Subject: City of Cleveland Department of Port Control Comments on FHWA
OH-EIS-09-01-D---Cleveland Innerbelt Project Draft Environmental Impact Statement

CITY OF CLEVELAND DEPARTMENT OF PORT CONTROL COMMENTS ON FHWA/ODOT DRAFT ENVIRONMENTAL IMPACT STATEMENT (CUY-90-INNERBELT, PID NO. 77510)

RE: POTENTIAL TO IMPACT BURKE LAKEFRONT AIRPORT (BKL)

**BURKE LAKEFRONT AIRPORT - MASTER PLAN UPDATE
 RECOMMENDED DEVELOPMENT PLAN**

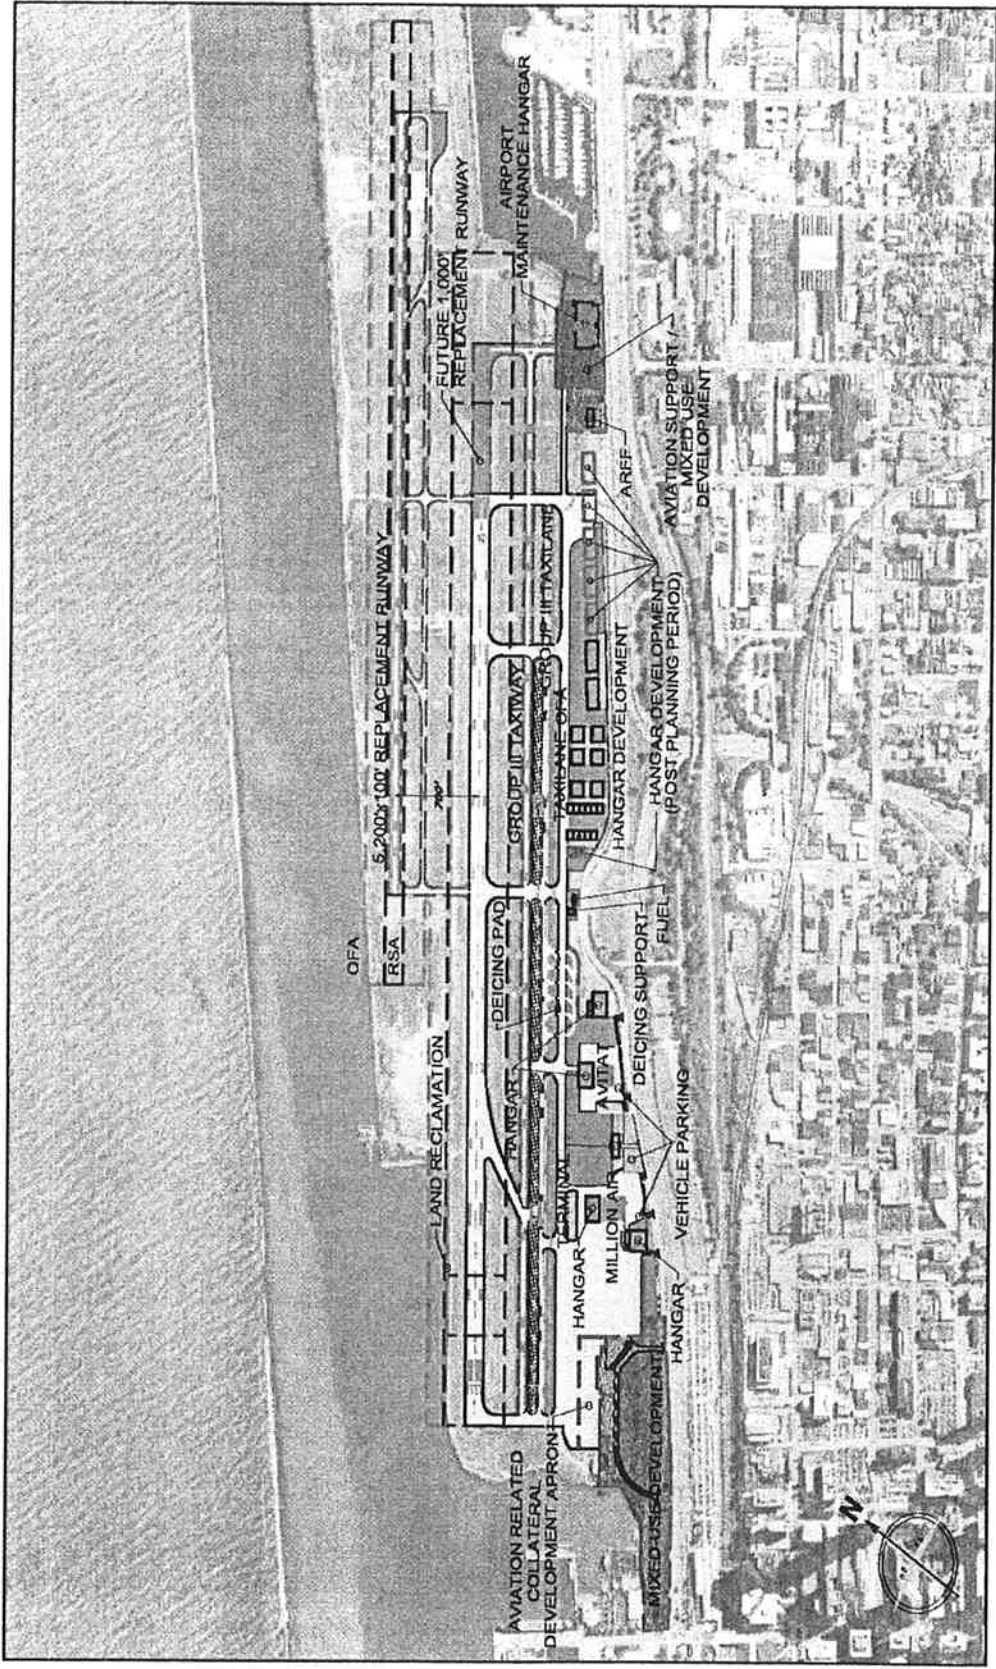
Despite the adjustments that have been made since the original concept developed by the agencies dating back several years, the current proposed layout appearing in the DEIS does not negate (or significantly mitigate) the adverse impacts on the development viability and value of the limited property available for aviation related development at BKL. The fact that (1) BKL already has a significantly constrained inventory of property for aviation related facility development; and (2) the announcement by the City that the airport would remain open, is resulting in a subsequent upsurge in inquiries from businesses interested in developing aviation related facilities at the airport, which results in the need to maintain the viability of property fronting North Marginal Road for airport facilities. This point has been clearly noted in the previous meetings with representatives of ODOT and the situation has not changed (See third exhibit, October 2007 Airport Layout and Future Development Plan for BKL). 2

Based on the proposed roadway realignment appearing in the DEIS, approximately 2 acres of property would be required to accommodate the actual relocation of North Marginal Road, the associated sidewalk, and the relocation of the on-airport perimeter roadway. However, this does not accurately represent the true and full impact of the proposal. What is not recognized by FHWA and ODOT in the DEIS is the fact that their impact to BKL extends beyond the 2 acres required for road construction. Development potential of an additional 3 acres of land lying adjacent to the proposed roadway alignment (beyond the 2 acres specifically noted by ODOT as required for the alignment) is adversely impacted and in some cases functionally negated by the roadway geometry and the resulting parcel

configuration of the remaining land parcels after the roadway is constructed. Thus, the impact of even the revised roadway alignment encompasses approximately 5 acres of an already limited developable land area. This point has been clearly and definitively made and discussed with ODOT in previous coordination meetings, but the issue is not included in the DEIS document.

**BURKE LAKEFRONT AIRPORT – MASTER PLAN UPDATE
EXISTING CONDITIONS**

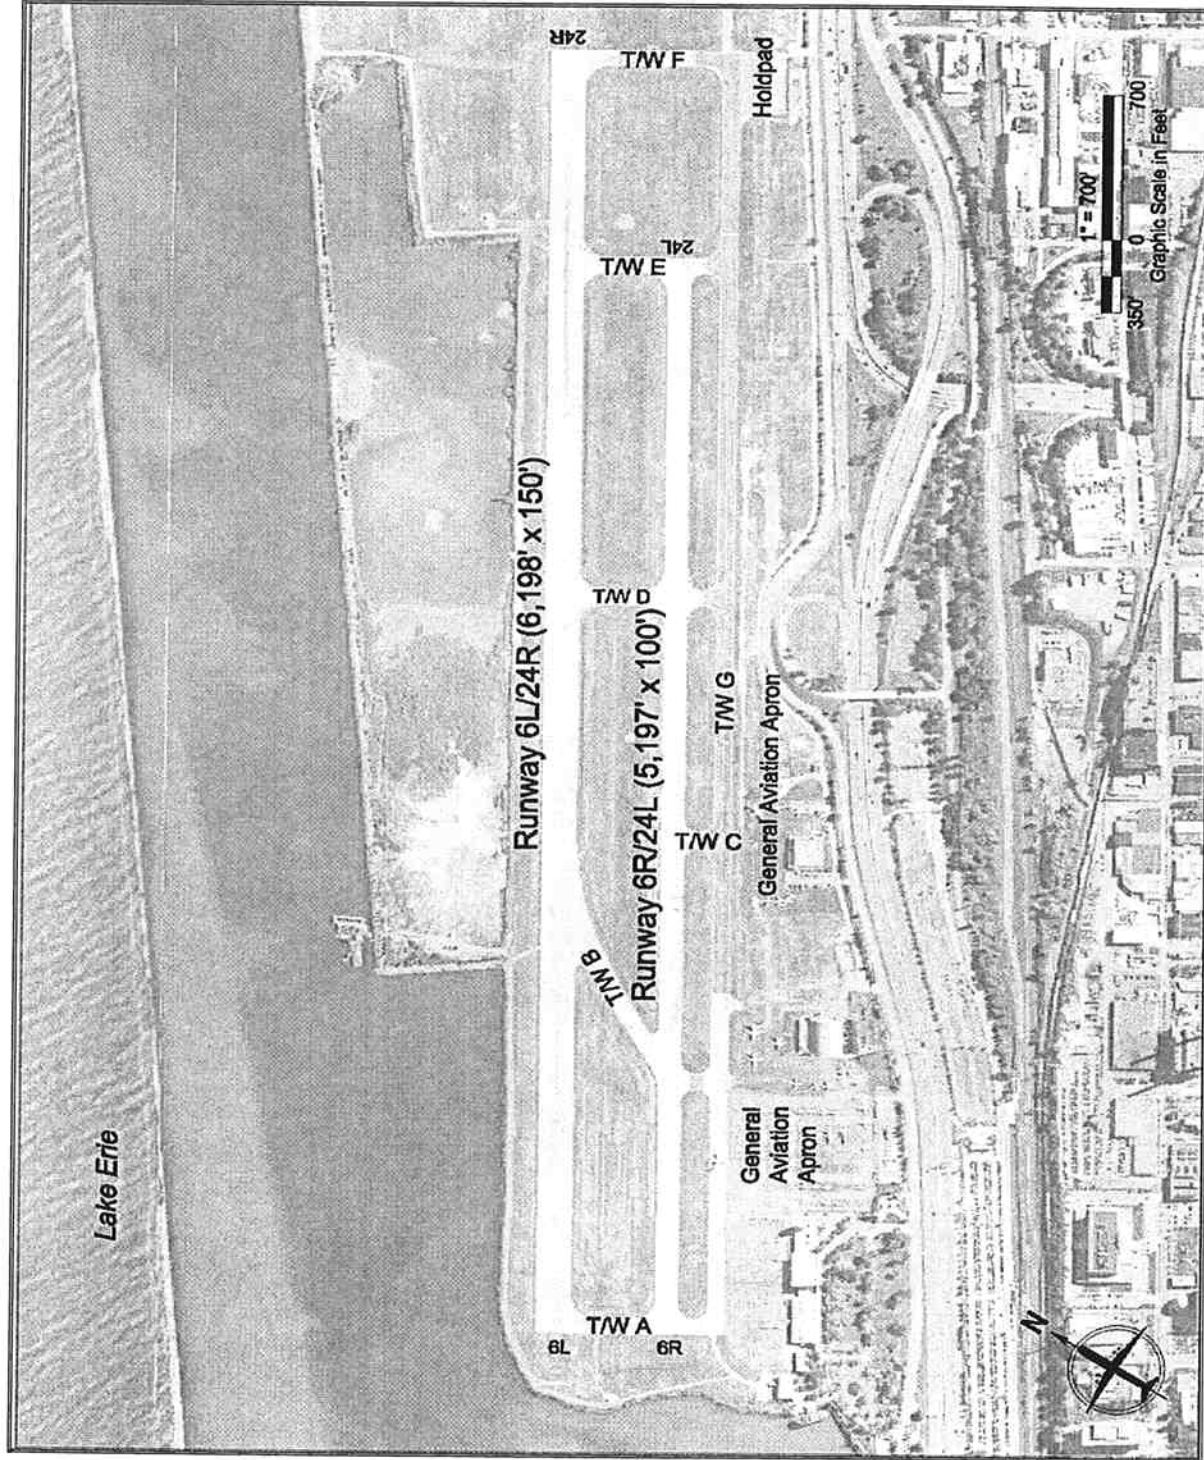
The City of Cleveland Department of Port Control (DPC) is the public entity assigned by the City of Cleveland Charter as the responsible agency for the operation, maintenance and improvement of Cleveland Hopkins International Airport (CLE); Burke Lakefront Airport (BKL--see first exhibit attached) and various City-owned harbor properties located in Cleveland.
